Report of the Chief Planning Officer

CITY PLANS PANEL

Subject: PRE-APPLICATION PRESENTATION OF PROPOSED DEVELOPMENT OF 79 RESIDENTIAL APARTMENTS, 1115 SQUARE METRES OF COMMERCIAL FLOORSPACE (A3/A4) AND NEW PUBLIC SPACE, 14-28 THE CALLS, LEEDS (PREAPP/13/00304).

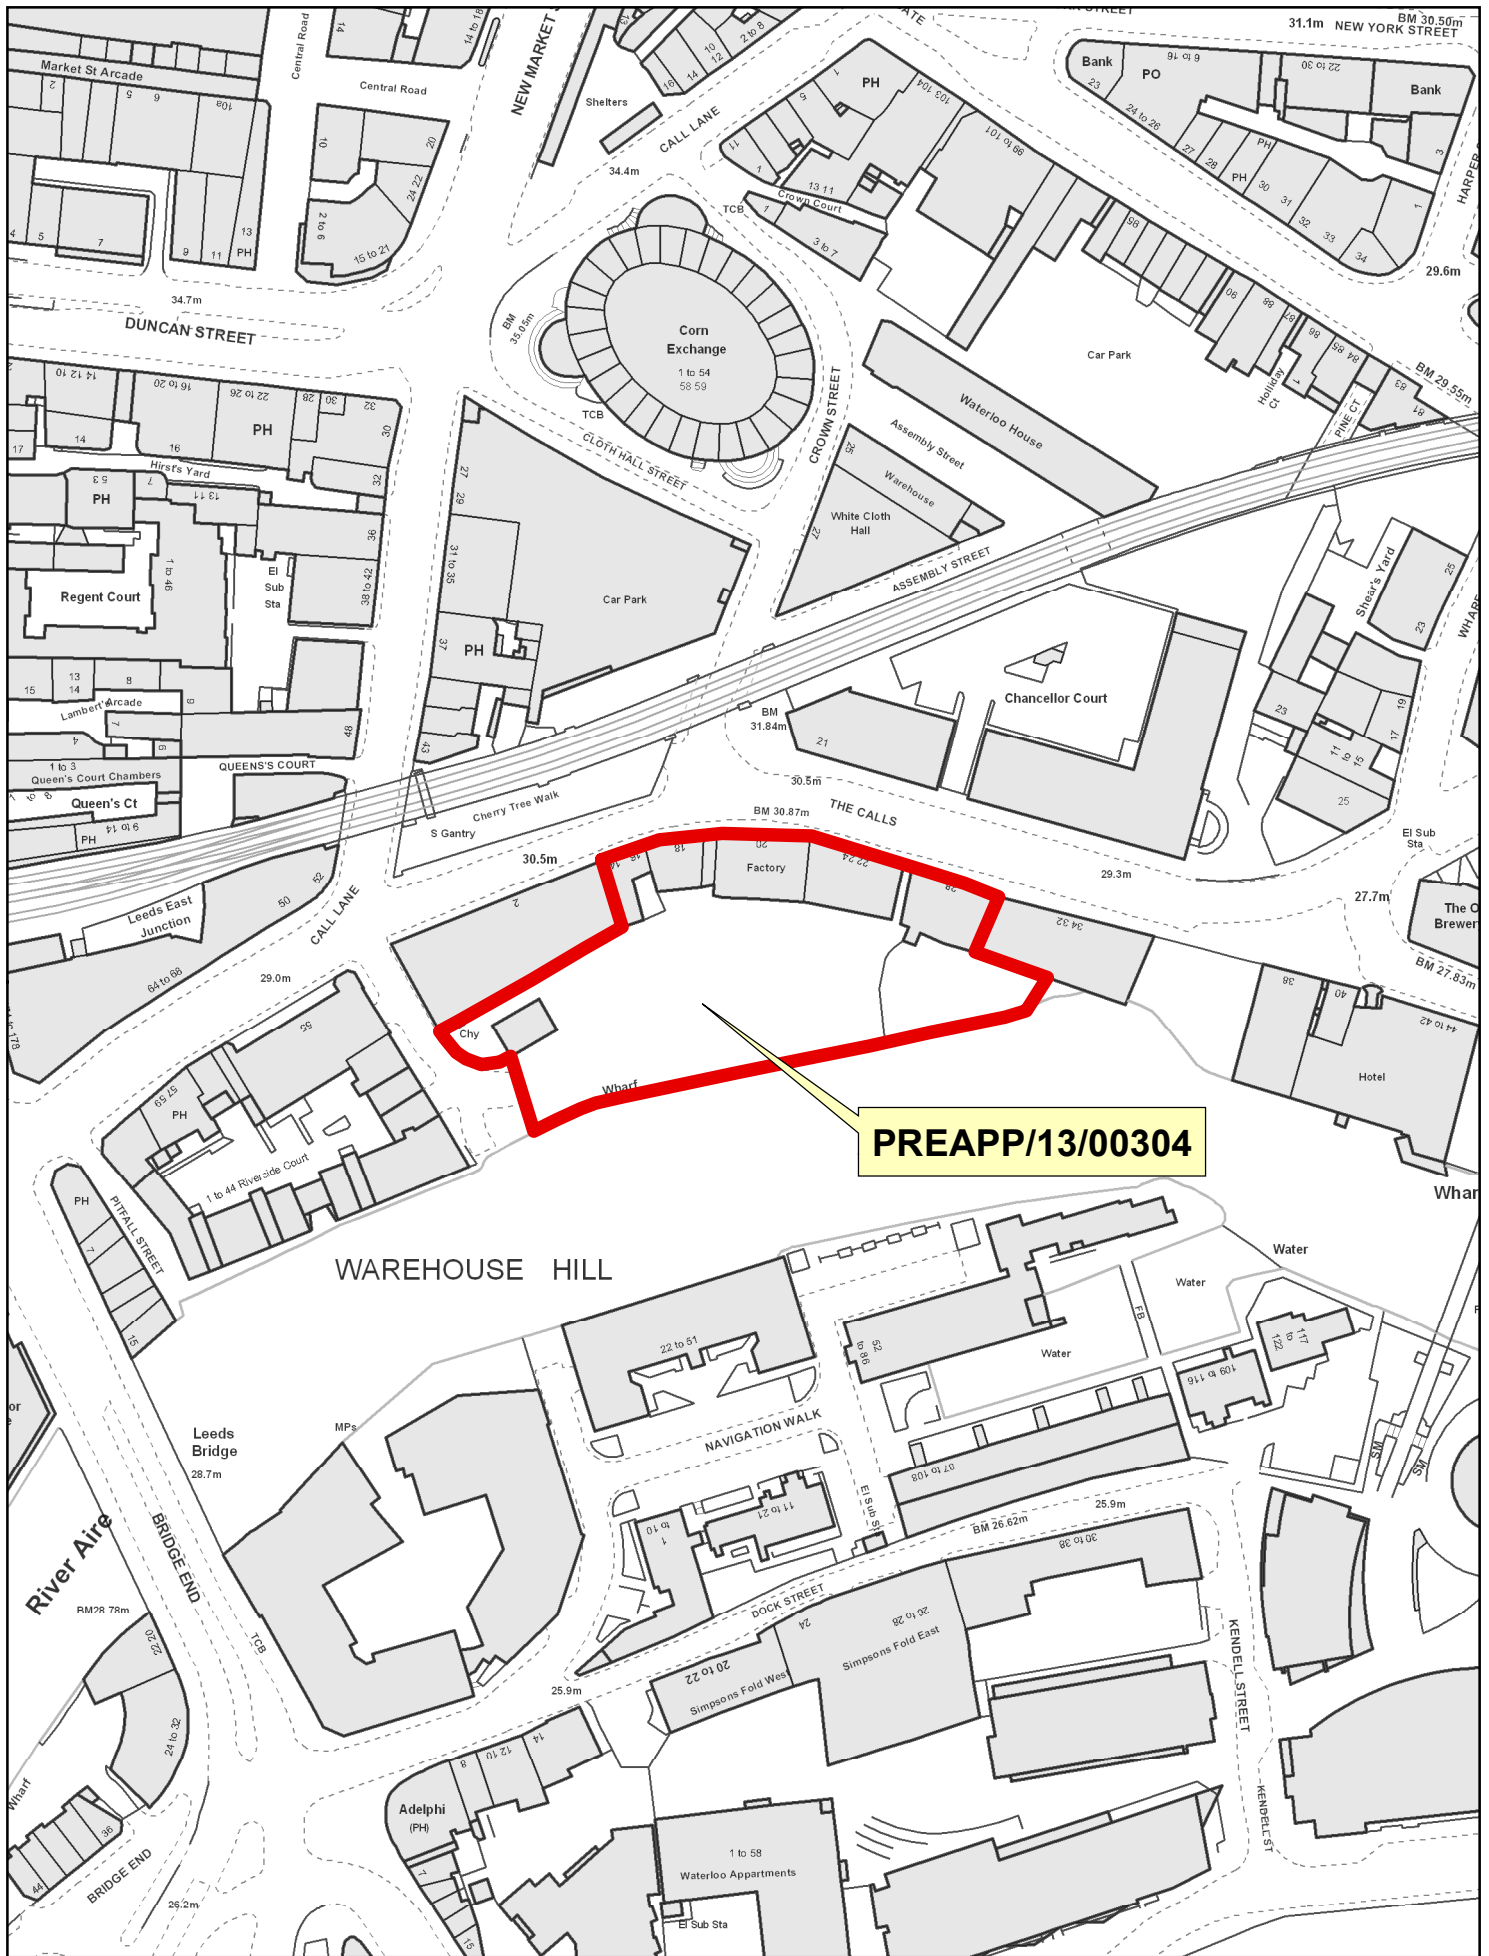
- 6.2.3 The depth of the riverside wing of the building is significantly reduced from that previously approved. This provides a greater separation to be achieved between the new building and offices in 2-12 The Calls. At the same time the western gable end of the building has an improved relationship with the proportions of 32 The Calls to the east.
- 6.2.4 The proposed layout involves an eastward extension of the riverside wing of the “L” shaped building towards the public space. The projection is reduced at ground floor level enabling access down to the river beneath upper floor levels of the building. However, the proposed arrangement is such that views from The Calls towards the river, opened up as a result of demolition of listed buildings fronting The Calls, would be reduced relative to the approved scheme.

Do Members agree that the larger public space is beneficial to the scheme but that as part of the justification for the demolition of 14-16 and 18 The Calls that more open views towards the river need to be achieved?
